## STAFF REPORT

APPLICATION RZ 2001-SU-034  
in association with RZ 2001-SU-035

**APPLICANT:** Madison Homes, Inc.

**PROPOSAL:** To rezone from the R-1 to the R-5 District to permit residential development consisting of nine (9) single family attached units.

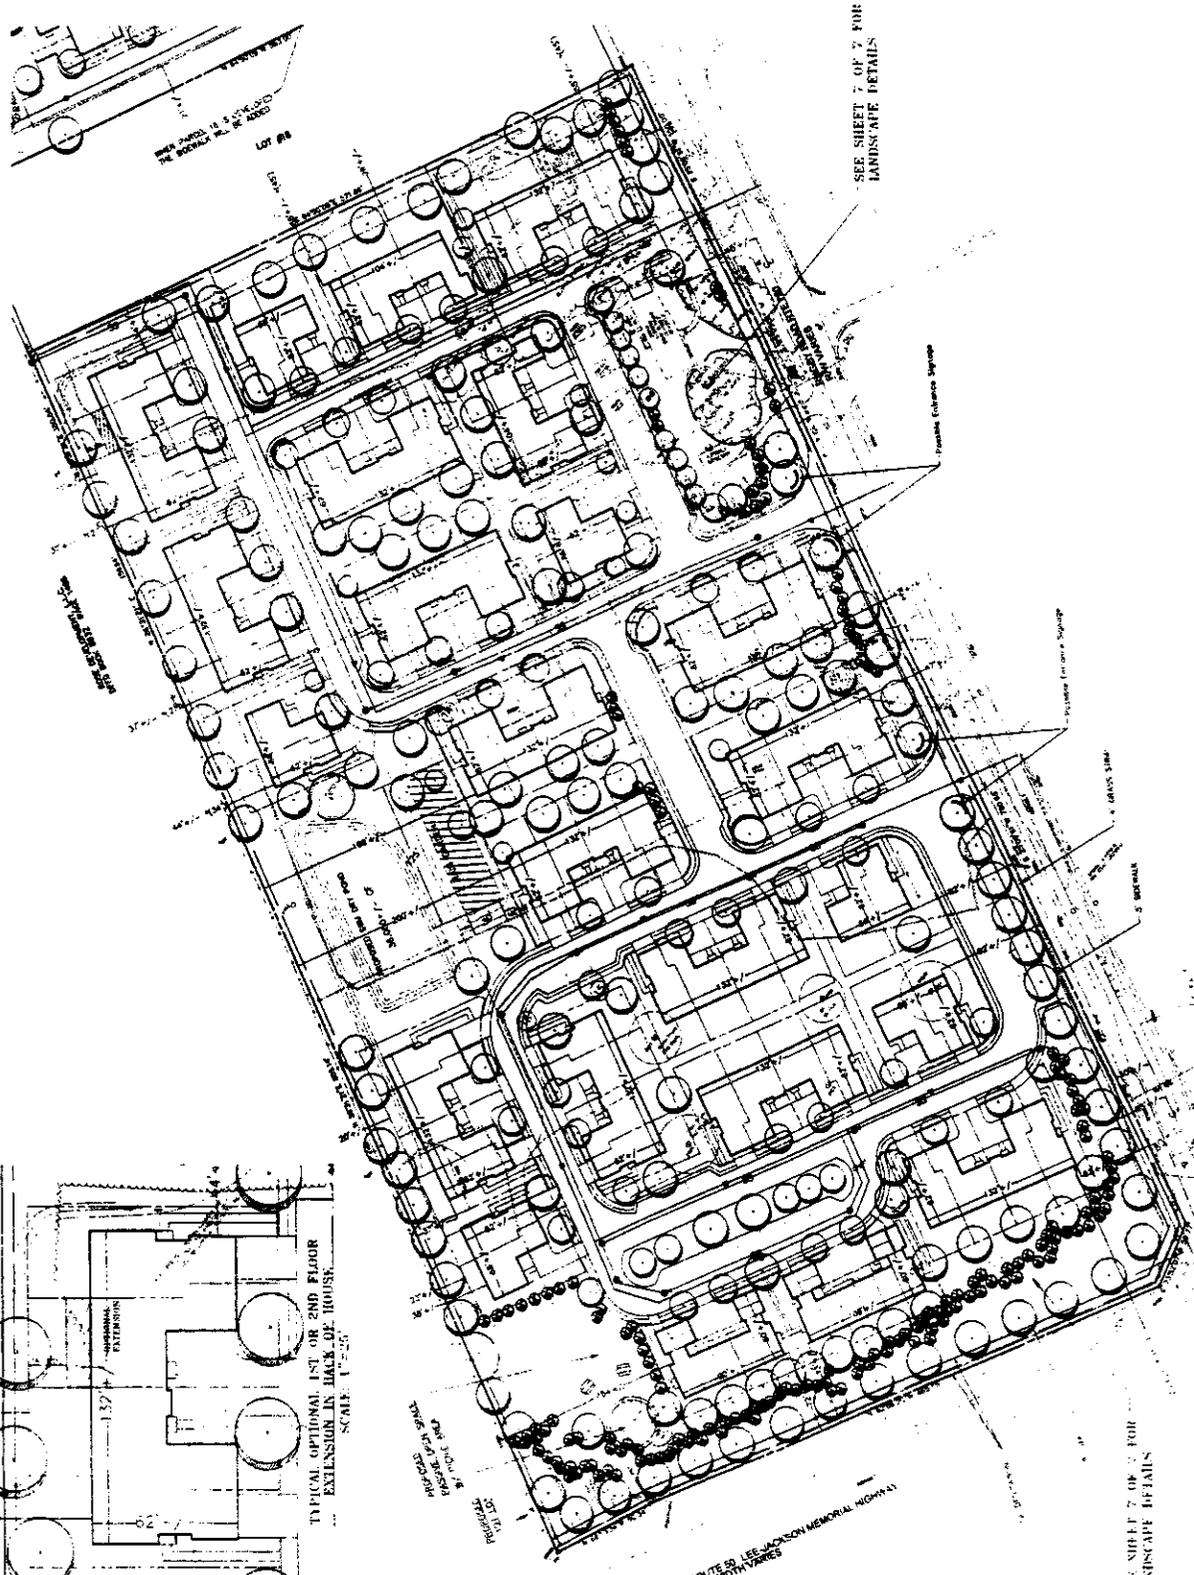
Recently adopted Comprehensive Plan language allows an increase in density conditioned upon the reduction of access points to Rugby Road. The applicant should therefore provide a plan with as few entrances as possible at the ultimate build-out, including no more than two entrances on the RZ 2001-SU-035 (larger) application.

As Rugby Road is planned to be a four lane facility with a median, the GDP should show at least one entrance at a location that meets the VDOT standards for distance between median breaks and intersections (Route 50 to the south and the Fairfax County Parkway to the north). It would be desirable if this entrance could be aligned with the existing entrance to the church on the east side of Rugby Road.

The sites have several areas of mature trees; the Urban Forestry Analysis (Appendix 8) indicates trees worthy of preservation near the proposed stormwater management pond and in the area of the open space area adjacent to Rugby Road. In addition, the applicant should commit to a tree preservation plan.

3. **Comment:** Sheet 4 of 5 labels existing trees as “possible trees to be preserved.” These trees are now shown to be removed; the entire site is shown to be cleared. Site design appears to preclude preservation of any of these trees.

The applicant has revised the GDP for application RZ 2001-SU-035 to show only two points of access to Rugby Road. In addition, the ultimate build-out schematic shows that no additional access point will be required to allow the un-consolidated parcel to develop. This issue is resolved.

The applicant has revised the GDP for application RZ 2001-SU-035 to locate the main entrance so that it meets the standards for the location of a median break. Although this is not directly aligned with the existing church entrance on the east side of Rugby Road, the church does control the parcel opposite the proposed entrance and therefore would have the ability to align with a median break. This issue is adequately addressed.

The applicant has revised the GDP to allow for preservation of the pin oak located adjacent to the stormwater management pond as well as those spruce in the open space area adjacent to Rugby Road. This issue is resolved.
